CHANGE ORDER NO. 1.

PEAKWOOD RESERVOIR

OFFICE OF CITY ENGINEER
ROANOKE, VIRGINIA

PARTIAL PLAN

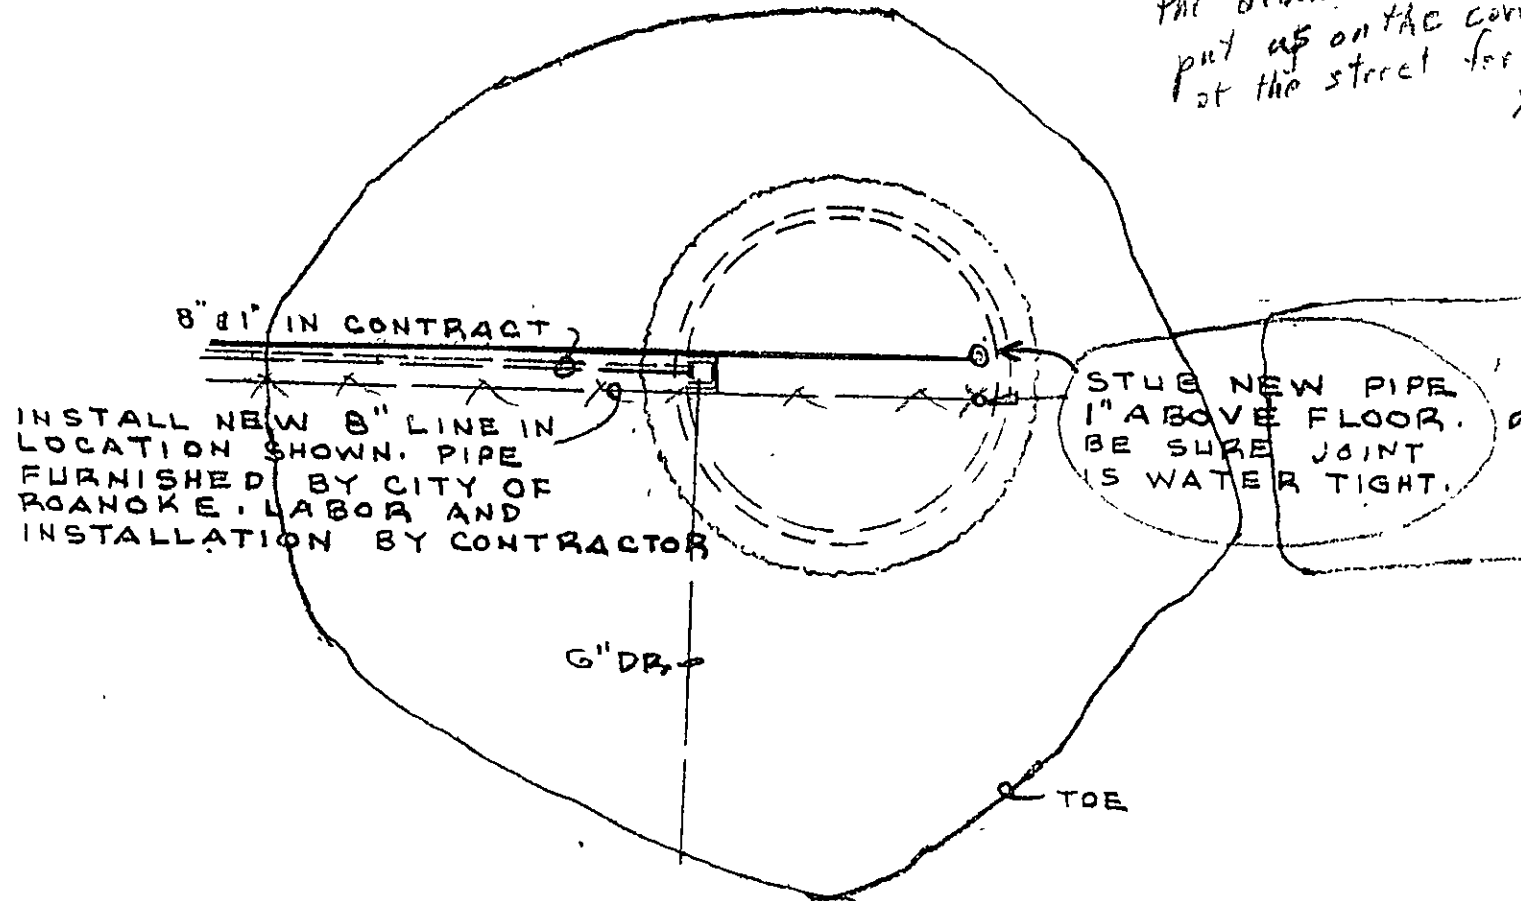
This will prevent interfering with
the drain & overflow lines and will
put us on the correct side down
at the street for hooking in.
